Product Change Notification - SYST-22TQTN001

ERRATA - AVR128DA28/32/48/64 Silicon Errata and Data Sheet Clarification Errata Document Revision

AVR128DA28/32/48/64

Silicon Errata and Data Sheet Clarification

2.4.1 Flash Mapping into Data Space Not Working Properly

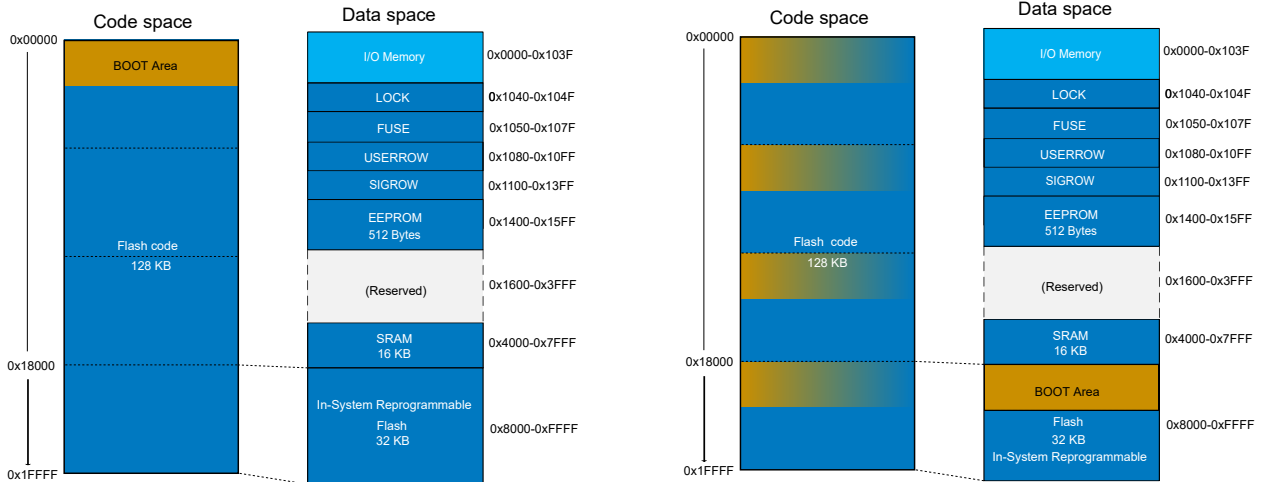
The inter-section Flash protection mechanism does not take into account the FLMAP bit field in the NVMCTRL.CTRLB register when checking if the address is in BOOT, APPCODE or APPDATA sections. It uses for comparison only the address offset between Flash start address in data space (0x8000) and the accessed address. This will cause the mirroring of the BOOT section in each Flash section selected by FLMAP (in blocks of 32 KB). See image below:

BOOT area for devices without issue

BOOT area for devices with issue

For read operations, the FLMAP bit field works as documented when the Boot Read Protect (BOOTRP) bit is not enabled.

For write operations, the inter-section Flash protection works properly only when FLMAP is set to 0x00.

Use only store program memory (SPM) instructions to write and load program memory (LPM) instructions to read Flash memory.
